**Responses to NRC Questions on WCAP-8859 (Non-Proprietary)  
and WCAP-8860 (Non-Proprietary)**

NS-CE-1694

February 13, 1978

Tranflo Logic for Selection Heat Transfer Coefficient

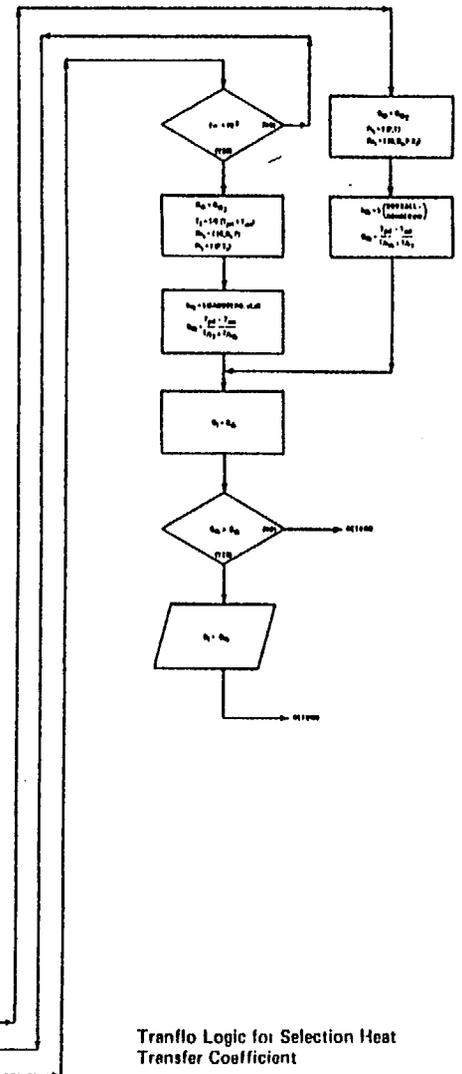
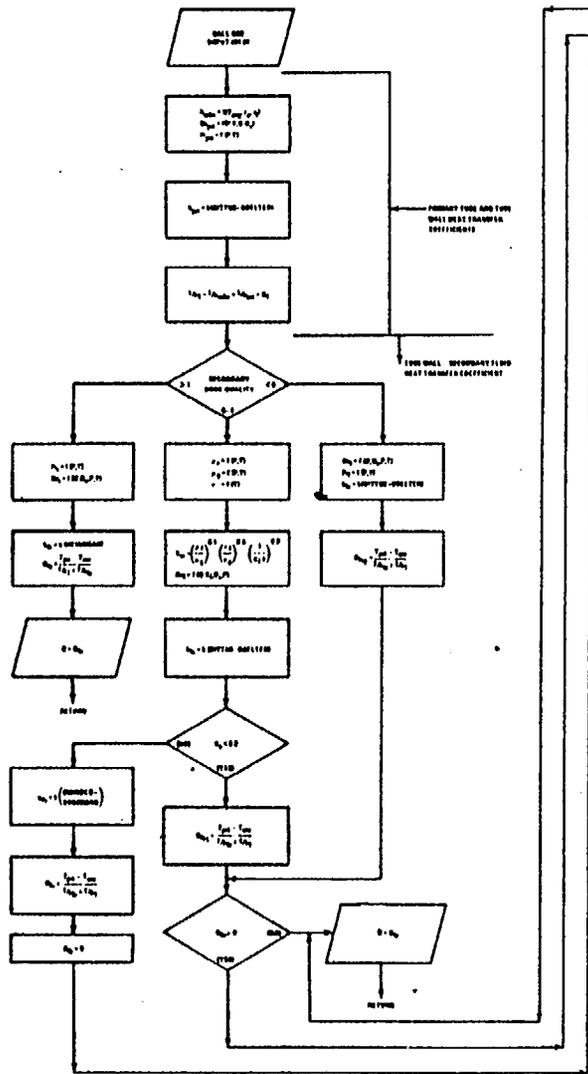
Page 2-12 of WCAP-8822 states that the heat transfer correlations used in the TRANFLO code to calculate primary-to-secondary heat transfer are designed to underpredict heat flow and thereby minimize entrainment.

- A. For each correlation listed in Section 3.4 of WCAP-8821, provide justification that heat transfer to the steam generator is conservative for calculation of entrainment.
- B. Provide additional details on the use of each correlation for heat transfer between (1) the primary system and the steam generator tubes and (2) the steam generator tubes and the secondary secondary for both the broken and intact loop steam generators. Provide the criteria for switching between correlations used in the TRANFLO code.
- C. Discuss the form of the Westinghouse transition boiling correlation used in the TRANFLO code. We understand that the correlation exists in a best estimate form and also in a form for ECCS LOCA calculations.

Page 2-12 of WCAP-8822 does not state that the heat transfer correlations used in TRANFLO are designed to underpredict heat flow. Instead, the statement is made that the primary temperature transients (input to TRANFLO) were selected such that energy transfer to the secondary side of the steam generator is conservatively low. Minimizing the energy transfer to the secondary side during a blowdown results in a lower steam pressure, and therefore, a lower blowdown flowrate. The lower flowrate, in turn, results in a higher average quality of the blowdown effluent.

The heat transfer relationships described in Section 3.4 of WCAP-8821 were chosen because they are commonly used, accepted, and appropriate empirical correlations to predict heat transfer in steam, steam/water, and compressed water systems. They are not selected to either overpredict or underpredict heat transfer, but were selected instead to predict accurately the actual energy transfer for a given set of thermodynamic conditions. Selection of the appropriate correlation from among those described in WCAP-8821 is accomplished using the logic illustrated on the attached flow chart. Also shown on the flow chart is the manner in which the primary film, tube, and secondary film coefficients are combined to give an overall heat transfer coefficient from the primary to the secondary.

The calculational methods discussed above and on the attached chart were used only for the steam generator with the broken steam line. Even then, the calculation was used only as part of the TRANFLO calculation of moisture entrainment versus time which was later used as input data to the MARVEL code. The MARVEL code, using the input entrainment information, then determined the heat transfer to both the steam generators with intact lines and the steam generator blowing down. The techniques of determining steam generator heat transfer in MARVEL are discussed in WCAP-8843, section 2.17.

Finally, the MARVEL calculated heat transfer to the faulted steam generator was checked to ensure conservatism with respect to the TRANFLO

calculations (see Section 3.2.1 of WCAP-8822). For clarification, a logic block diagram of the analysis steps used for determining the releases from the various breaks is attached.

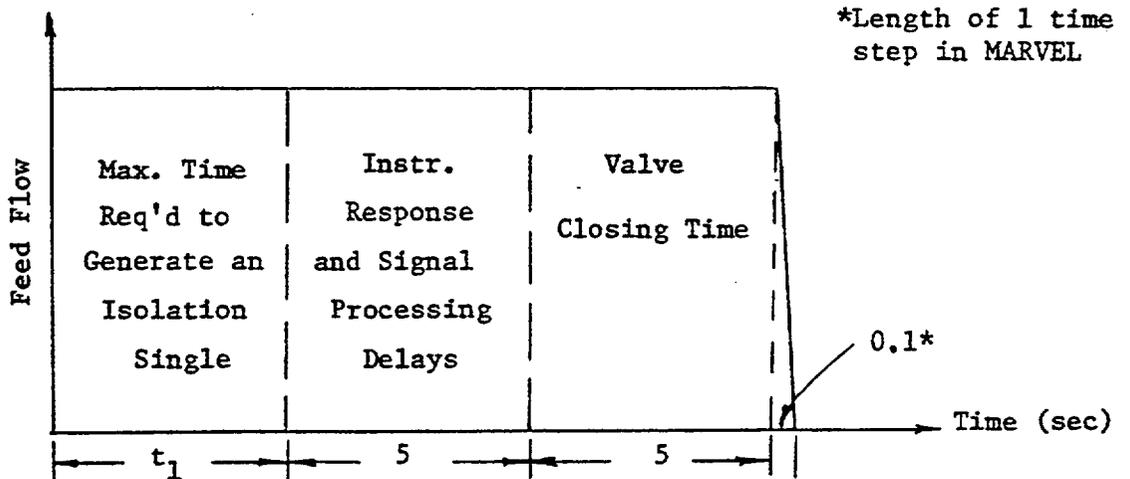
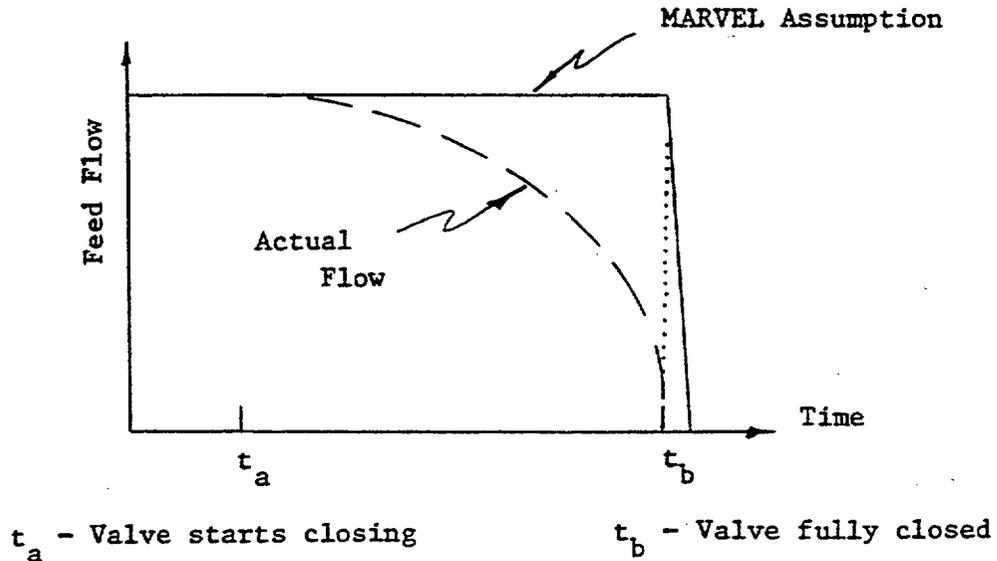
Provide additional details of how the main feedwater flow to the ruptured steam generator is calculated before isolation. Discuss how the trip times given on page 4-20 and the five-second isolation time given on page 3-12 are used to calculate the feedwater isolation times given on page 3-16. Discuss how the feedwater isolation setpoints and isolation times in the tables of Part IV of Appendix A were determined. For each break provide the total amount of main feedwater assumed to flow to the ruptured steam generator. Discuss the methods by which applicants should calculate containment mass and energy release data in the event that feedwater flow exceeds the amounts assumed by the MARVEL code.

Feedwater flows used to determine the mass/energy releases presented in WCAP-8821 were not calculated. As discussed in Section 2.2.3, the TRANFLO studies to determine entrainment were performed assuming that the feed flow to the steam generator remained at its initial value for 10 seconds. This was done to minimize water entrainment since higher feed flows would have resulted in lower quality blowdowns in the TRANFLO calculations. However, since quality versus time data from TRANFLO was input directly to MARVEL, the MARVEL analyses assumed conservatively large feed flows to maximize the mass available in the steam generator for blowdown. The values of feed flow used in the MARVEL analyses are those quoted at the top of Page 3-16.

The time during which main feed is supplied to the steam generators in the MARVEL analyses for each of the doubled ended ruptures is also given on Page 3-16. The flow was held constant at the specified value for this entire time period. The series of factors which make up each of these times are defined in the sketch below.

The values chosen for each of the factors are conservative for several reasons. Functional design requirements for protection instrumentation and process equipment, for example, require that response and processing delays be much less than 5 seconds. as is conservatively used in these analyses. In general, these times on the order of 0.5 - 1.5

seconds depending upon which protection signal is considered. Also, though design requirements for isolation valves specify a maximum of 5 seconds for closure following a trip signal, closing times are often much shorter, and the flow versus time (during closing) follows a trend much like that shown below rather than the step change in flow used in the MARVEL analyses.

Further conservatism is included in  $t_1$ . The  $t_1$ 's used were determined with the MARVEL code by analyzing a large number of blowdowns from many break sizes and power levels to identify the set of input assumptions resulting in the longest delay prior to reaching a trip setpoint for isolation. These assumptions were then used to establish  $t_1$  for the breaks and power levels of interest. Conditions found to be important were the use of low feedwater flow rates prior to trip, correcting turbine steam flow for the steam pressure decay prior to turbine trip, assuming dry steam blowdowns, and using high values of initial steam generator mass. All of these assumptions tend to increase the rate of steam pressure decay following the break. Because this process was used, the values of  $t_1$  used to arrive at the times listed on Page 3-16 are generally significantly longer than the actual time that would be required to reach the isolation setpoint were more appropriate assumptions
